Town of Windham

MEMO

- TO: Windham Planning Board
- FROM: Amanda Lessard, Planner
- Cc: Dustin Roma, P.E., DM Roma Consulting Engineers Development Review Team
- RE: 18-18 River Road Condos Minor Subdivision, Sketch Plan Planning Board Meeting: July 9, 2018

Aerial View of the subject parcel relative to surrounding properties and street network.

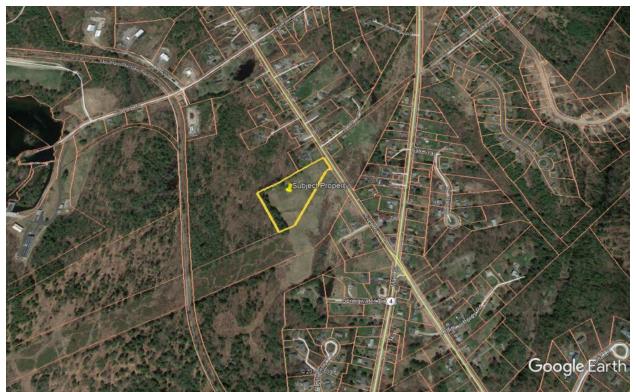
The applicant is proposing a 4 unit/2 duplex condominium development on a 5.98 acre undeveloped property on River Road. The property is located in South Windham, between Route 202 and Gambo Road. The front 300 feet of the parcel is zoned RM and the rear of the parcel is zoned FR. The development is proposed within the RM zone and utilizing Section 404 the Land Use Ordinance that states that where a land use district boundary line divides a parcel the regulations applicable to the less restricted portion of the lot may be extended 50 feet into the more restricted portion of the lot.
